## **PLANNING & ZONING COMMISSION MEETING**

**Monday July 15, 2024**

HUXLEY, IOWA  
ANTHEM PLAT 2 (120 SOUTH)  
FINAL PLAT

**RE: Anthem Plat 2 Final Plat (2nd Submittal)  
Comment Response Letter**

# ANTHEM PLAT 2 FINAL PLAT

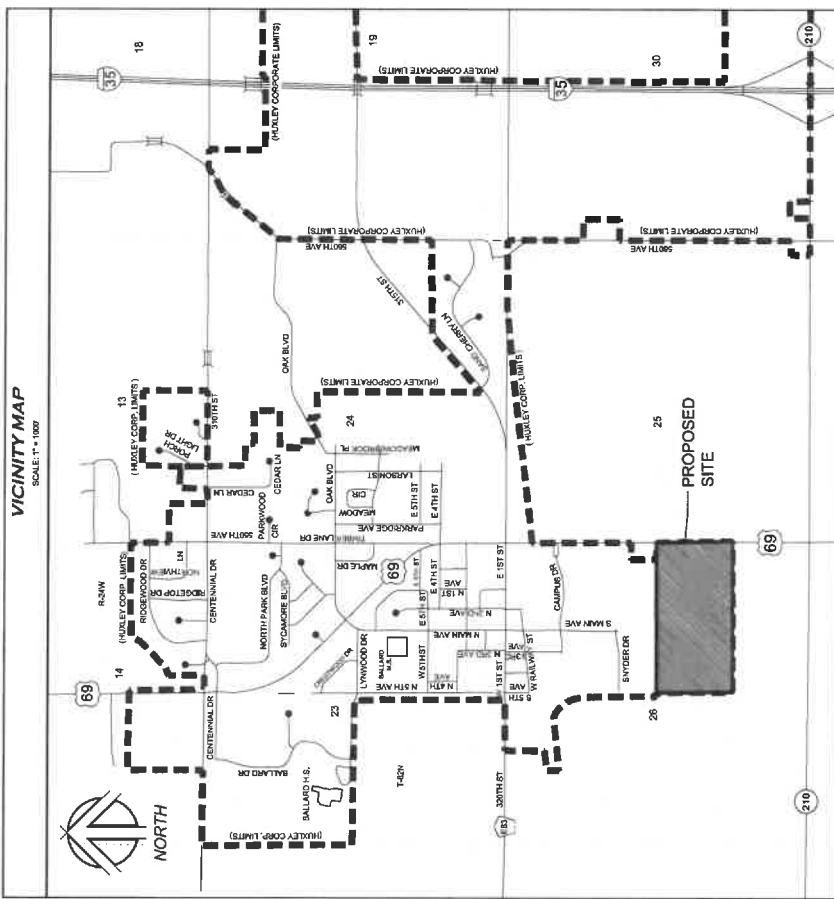
We have reviewed the final plat for Anthem Plat 2 (120 South) and find it acceptable.

We still need confirmation from the Iowa DOT that the trail located on the west side of the highway will be allowed to be within the right-of-way and that a trail easement will not be needed along the east plat boundary.

1. Change the storm sewer easement to an overland drainage easement along the north side of Lots 15, 16, 17. Maintain the storm sewer easement in the northeast corner of Lot 17. **Easement has been updated.**

2. Provide an overland drainage easement and a storm sewer easement across the south side of Lot 13. **Easement has been added.**
3. Provide an overland drainage easement along the entire south side of Lot 9 from the north line of the storm sewer easement to the south plat boundary. **Easement has been added.**

4. Provide storm sewer easements over the storm sewers in Outlot X, Outlot Y, and Outlot Z. **Storm sewer easements have been added.**
5. Provide a storm sewer easement in the southeast corner of Lot 14 over the storm sewer and intake. **Easements have been added along the south side.**

6. Provide a storm sewer easement along the storm sewer located at the east side of Lot 6. **Storm Sewer easement has been added.**
7. Provide a storm sewer easement along the storm sewer located in the northeast corner of Lot 7. **Storm sewer easement has been added.**

8. Provide storm sewer easements around the intake in the northeast corner of Lot 5 and the storm sewer along the east side of Lot 4. **Storm sewer easement has been added.**

9. Provide an overland drainage easement along the north side of Lot 3 and the northeast corner of Lot 4. Extend the easements to the north plat boundary. **A drainage easement has been added to the north side.**

10. Provide a storm sewer easement along the storm sewer located in the northeast corner of Lot 2. **Storm Sewer easement has been added.**
11. Provide a storm sewer easement along the storm sewer on the south side of Lot 3 in the middle of the lot. **Storm Sewer easement has been added.**

12. On the south side of Lots 15, 16, and 17 change the 10' P.U.E. to 10' sanitary sewer easement. Move 10' P.U.E. to north side of the sanitary sewer easement. **Easements have been updated.**

13. Extend the sanitary sewer easement on the north side of Lot 9 to the west lot line of Lot 9. **Sanitary sewer easement has been extended.**
14. Label Highway 69 on Sheet 2 **Label has been added.**

15. Dimension the width of the existing gas easement on Sheet 7. **Easement is labelled as 60' wide.**
16. Sheet No. 1, Note 3, add Outlot Z. **Note has been updated.**

17. Sheet No. 1, Note 5, provide information on where Outlots A and B are located. **Note has been removed.**
18. There appears to be no Lot Nos. 1 and 10. Renumber lot numbers so no numbers are not skipped. **Lots have been renumbered.**

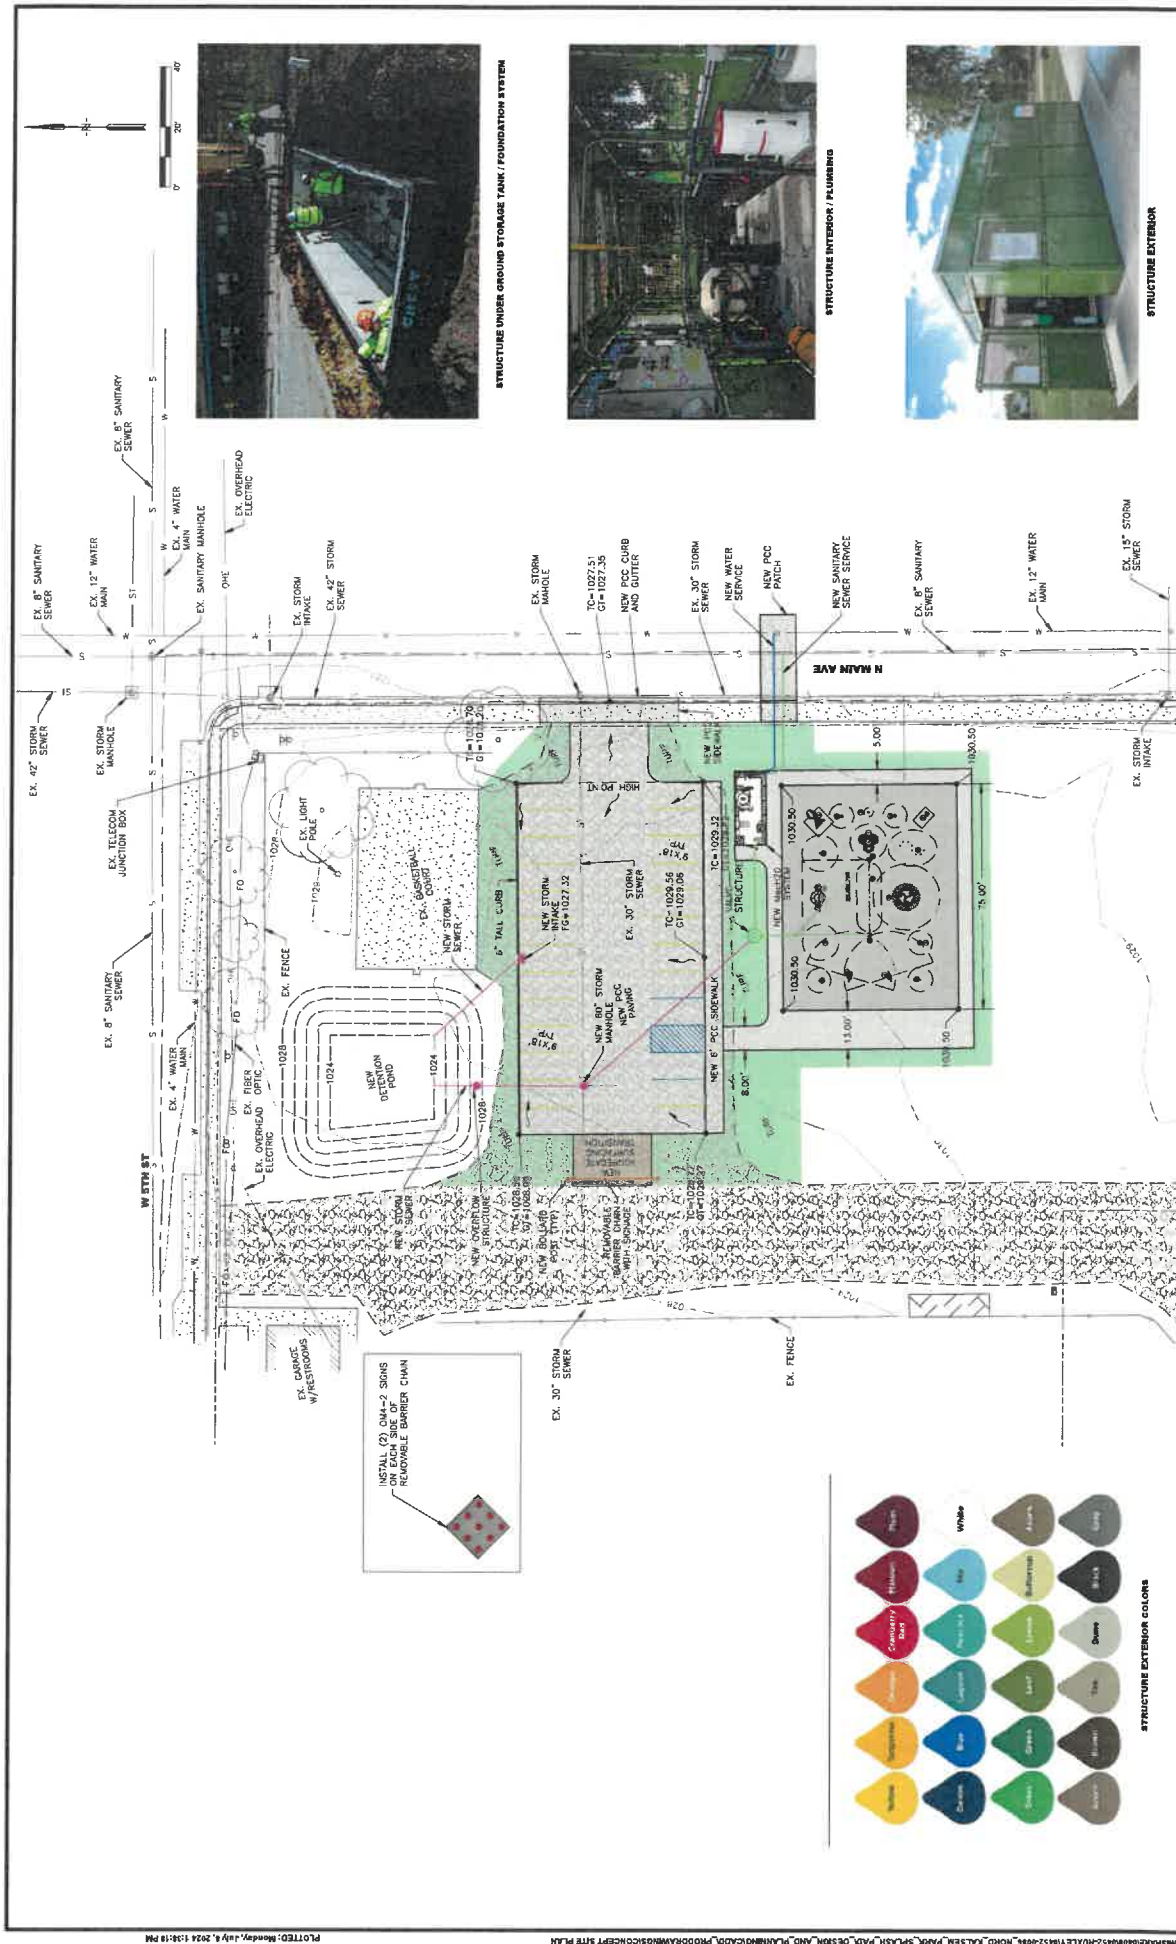
Attached is the latest site plan for review and comment for the splash pad. Several comments.

1. Review the location of the control building. The location shown is close to the sewer and water on Main Ave. reducing cost and is convenient for operation and maintenance from the parking lot. However, it visually will block the splash pad from the street and parking lot.

2. We are showing a 6" high concrete curb along the west side of the parking lot. This is intended to keep cars in the parking lot from leaving to the west but still allows emergency vehicles to jump the curb and exit. We might need a sign off of 5<sup>th</sup> stating no splash pad access or maybe everyone will figure it out.

3. Since we are adding a concrete curb on the west side of the parking lot, we went ahead and added a concrete curb on the north and south sides too. This adds about \$6,000 to the project cost.

4. We are showing a stormwater detention basin to be added west of the basketball court. This would be a normally dry grass basin. There isn't much more additional stormwater runoff from a paved parking lot vs a gravel parking lot but there is from the splashpad. We could probably get by without it but politically we may want to have a basin.

5. We deleted the sidewalk running along the north side of the parking lot. Cost of the sidewalk for the entire length of parking lot is approximately \$5,000.

After further review... and talking to Dave we think a sidewalk on the South side of the parking lot would be good. How much would it be approximately for each sidewalk (North – South)? Will there be a curb on the parking lot? We both agree we do not want through traffic (unto the alley way) We could barricade if needed.

- No paved entry off West.
- Sidewalk North side not needed but what would cost be?
- Grass between lot/basketball court.
- Sidewalk South side of parking lot okay.

1. Do we want to pave the west driveway entrance? The busses use this entrance, so it would need to be concrete.
2. Do we want a sidewalk along the north side of the parking lot?
3. Do we want to connect the basketball court to the parking lot with pavement? Sidewalk from the court to the parking lot? Grass strip?
4. Do we want a sidewalk along the south side of the parking lot?
